**CITY OF WEST DES MOINES  
STAFF REPORT COMMUNICATION**

**ITEM:** Amare Vita at High Pointe, Southwest corner of the future intersection of Stagecoach Drive and S. 81<sup>st</sup> Street – Approve a Preliminary Plat to create 60 footprint lots for Multi-Family Residential development and Approve a Site Plan to allow construction of 60 detached townhomes – MavenCrux Development – PPSP-006132-2023

**Resolution: Approval of Preliminary Plat and Site Plan**

PROJECT NO.: 08937.001  
**A4.0B**

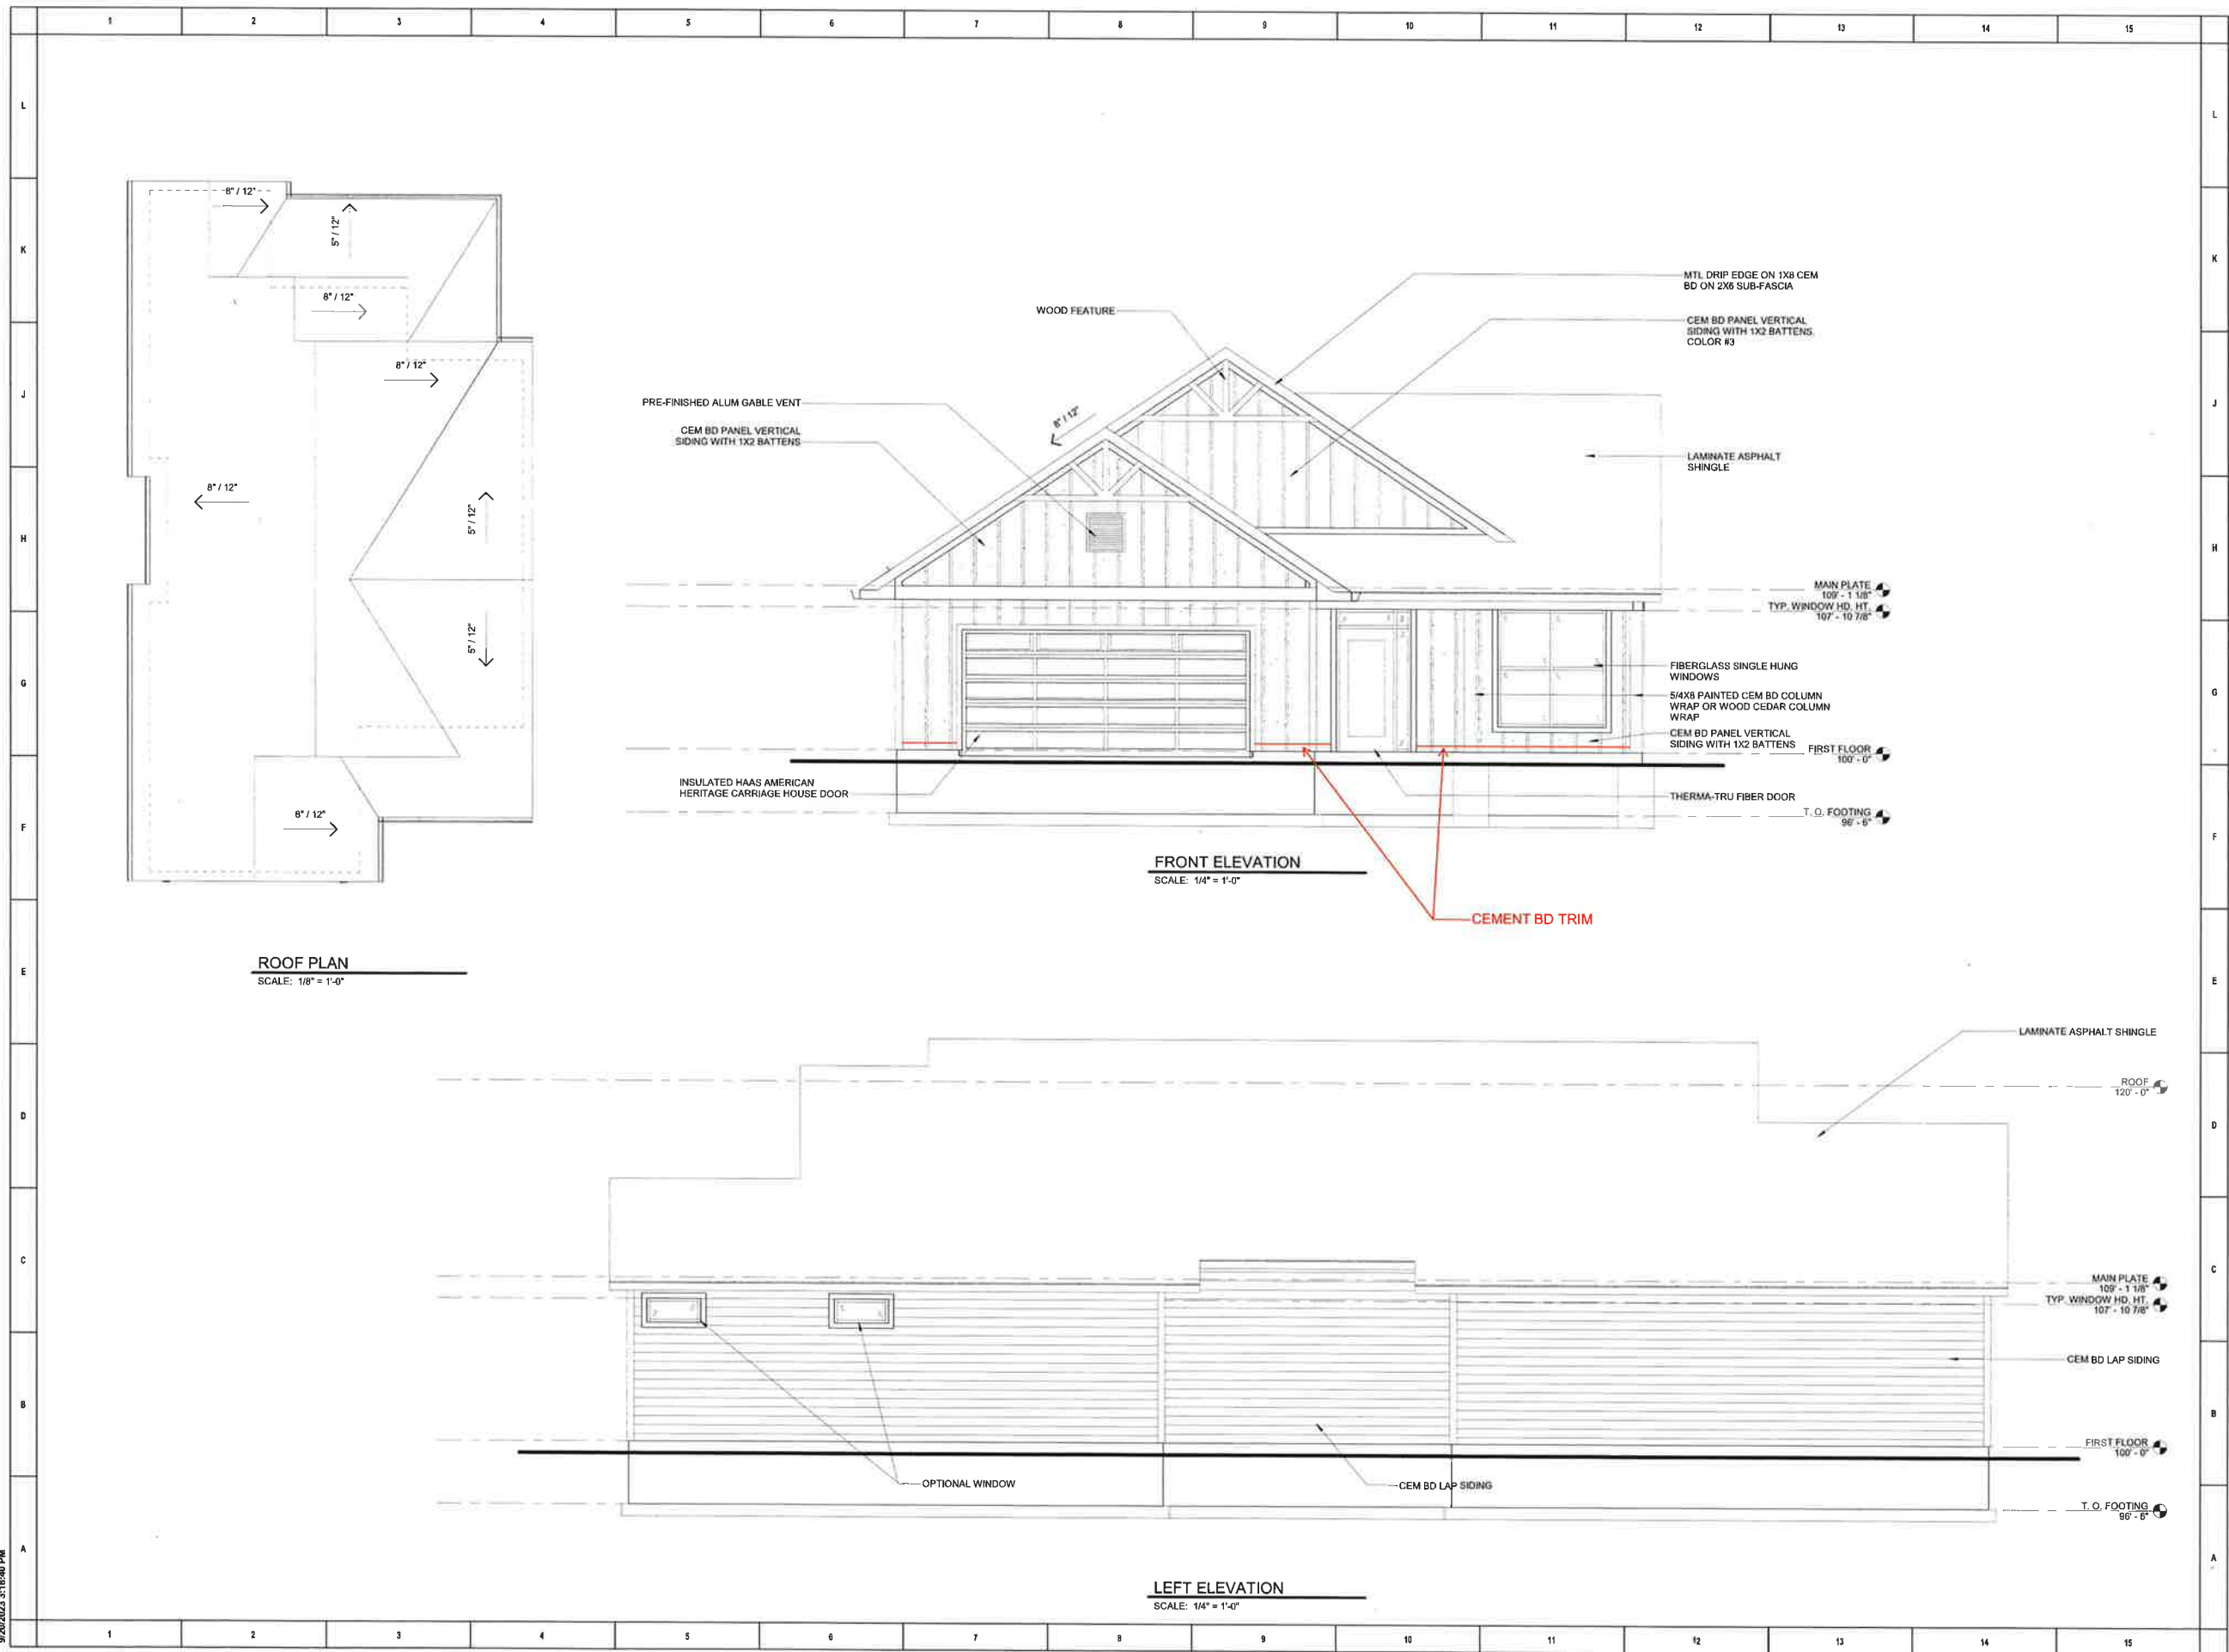
2. Building Architecture: The applicant has identified 6 ranch models for the proposed detached townhomes, with each model providing an alternate front elevation with some variation in building materials, including masonry, but only on the optional facades if desired by a potential buyer. Five of the six models also provide for an alternate partial basement with walk out option. The buildings use a farmhouse style front façade design using a black, white and gray color scheme. The exterior cladding is primarily composite material in three patterns. Black or white board and batten siding is used on the front façades of all six base models, with the side and rear facades being clad with a horizontal lap siding pattern. Gray shingle siding will be used in limited areas as an accent material. The optional front facades for each model, if chosen by the homebuyer, will provide masonry as an option for portions of the board and batten siding.

- Use of Masonry: Masonry is typically used as a secondary or accent material on all multifamily projects in the city to provide a visual element of permanency to the structures. Being these units appear as single family detached dwellings, a more limited use has been acceptable when used in appropriate public view areas of the building. The applicant has chosen to only provide masonry on the alternate façade options, if/when chosen by the homebuyer. Staff has some concern that very limited, if any, masonry may be present when the development is completed. The applicant has noted they anticipate 50% of homebuyers will choose to provide the masonry elements; however, there is no guarantee. As an alternate to providing masonry on the base models staff has requested that enhanced trim and detailing be provided on facades without masonry to enhance the perception of quality design and to provide a finished edge to the siding along the foundations. The applicant has provided window and door trim and trim along the gable ends, however, band boards at the base of wall facades has only been provided along the front facades without continuing to side or rear facades.

- Areas for change of materials on the building: A design detail that staff has requested in all developments throughout the city is the starting and stopping of materials at appropriate areas of the building, such as changes in building footprint,

at inside corners, or where there is an architectural element or change in roof form to both provide authenticity to the material and to help enhance the view of that area of the building as a three-dimensional element, not just a faux facade. Staff has discussed with the applicant areas of the building models where there are changes in materials that do not meet the intent of typical design review for the city, such as at the front facades where the board and batten material is proposed to change to horizontal siding on the side facades, or the stopping of trim at the front corners. Staff would suggest finding appropriate opportunities to change materials, such as inside corners, change in roof form, with an engaged column or corner element, or minor shift or projection of the façade to provide an architectural element to warrant a change in materials.

Staff is recommending a condition of approval requiring the resolution to the satisfaction of staff or as otherwise directed by the Commission and Council of these design elements. Additionally, staff is recommending a condition of approval requiring and agreeing to the identified public view facades and submitting a drawing specifically identifying all facades that are to be enhanced.

4. Prior to issuance of a building permit for above ground construction of any unit within the development, the applicant providing architectural plans that resolve remaining architecture material and design issues as discussed above to the satisfaction of City Staff.

**A4.1B**

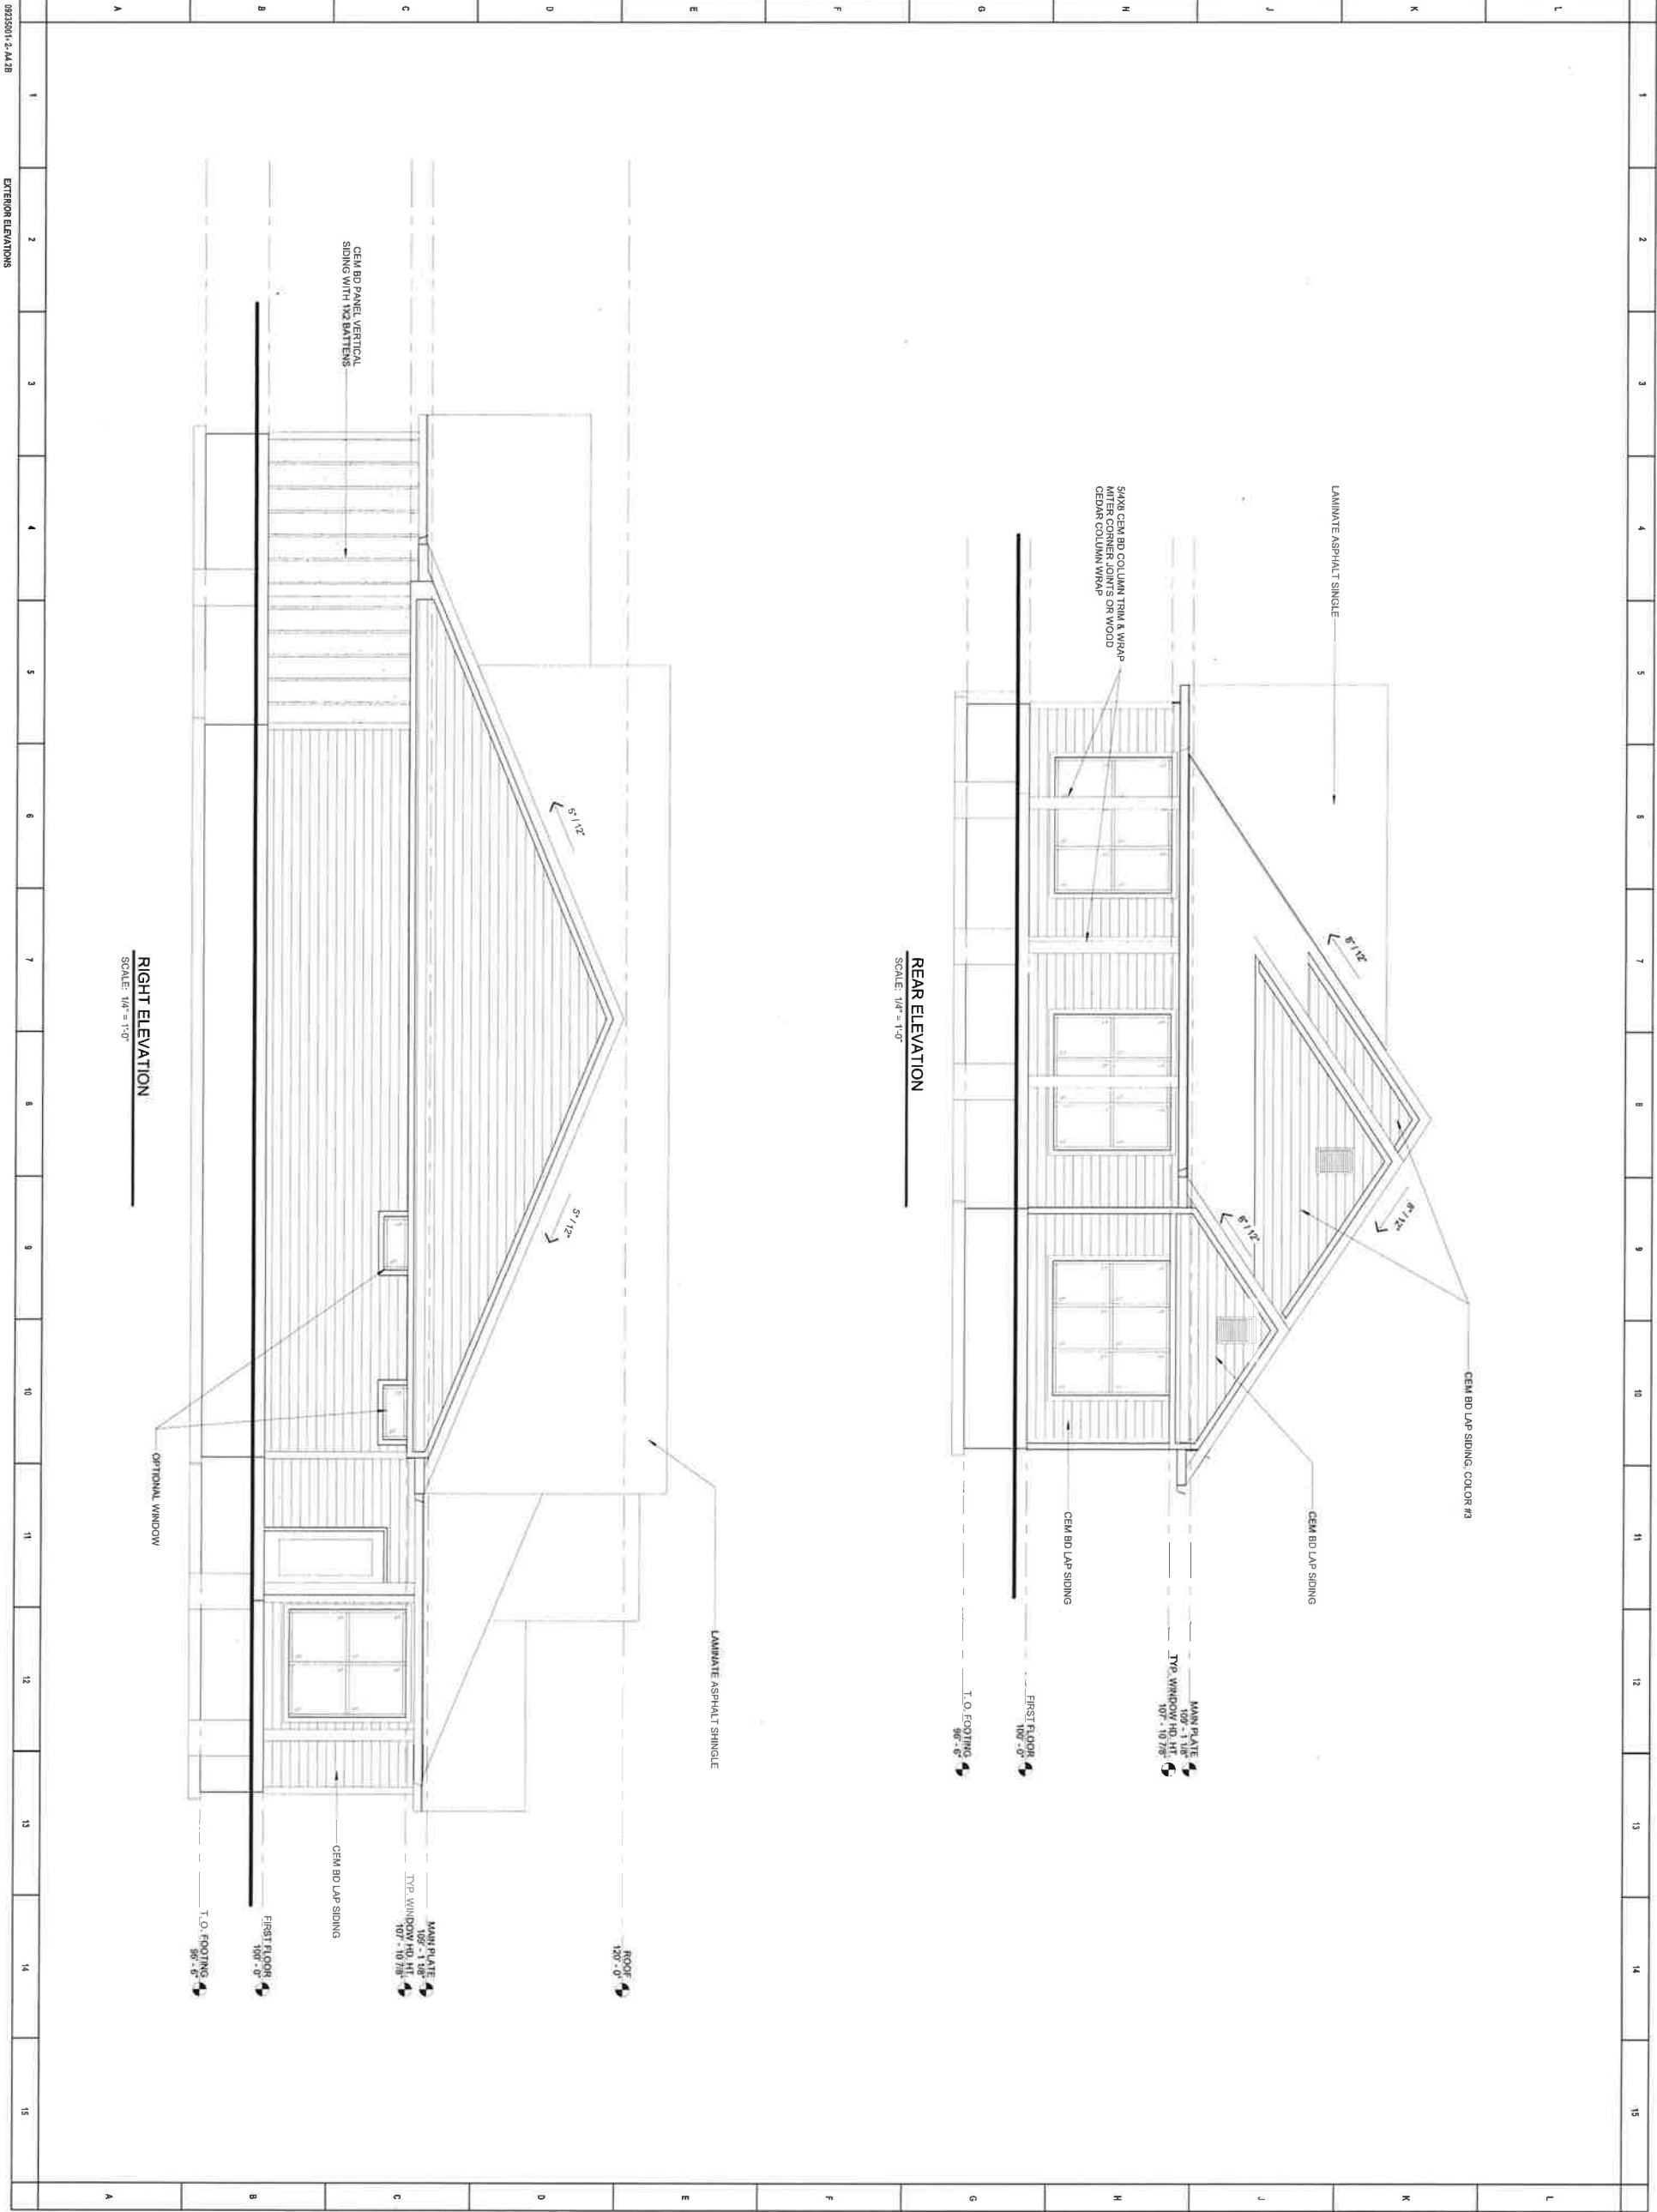
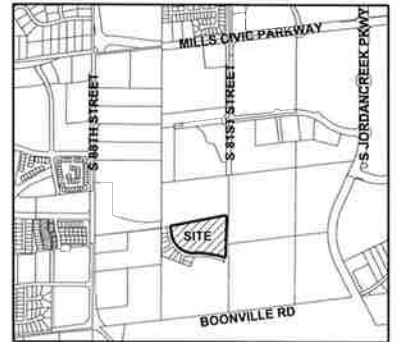
- Public View Facades: During design review staff looks for buildings to provide more detail such as, additional openings, variation in materials or colors, or enhanced façade elements on sides of the buildings which provide public views into or within the development. Facades with more limited views such as sides between buildings or limited visibility rear façade can be reduced in architectural detailing. The applicant has provided alternate public view elevations for the 5 lots at the entries to the development, however, staff would consider enhanced public view facades be provided on additional lots within development that would also be viewed as public facades. Staff would suggest, in addition to the 5 lots identified by the applicant, lots 1, 16, 17, 26, and 60 on the outer ring of the development, and lots 36, 40, 41, 43, 44, and 55 on the inner ring of the development also provide public view facades.

3. Prior to issuance of a building permit for above ground construction of any unit within the development, the applicant agreeing to provide enhance facades for those units identified within the staff report and providing a drawing that clearly indicates the units which are to have enhanced public view facades and architectural plans demonstrating the additional details and elements to be incorporated for each of the buildings.
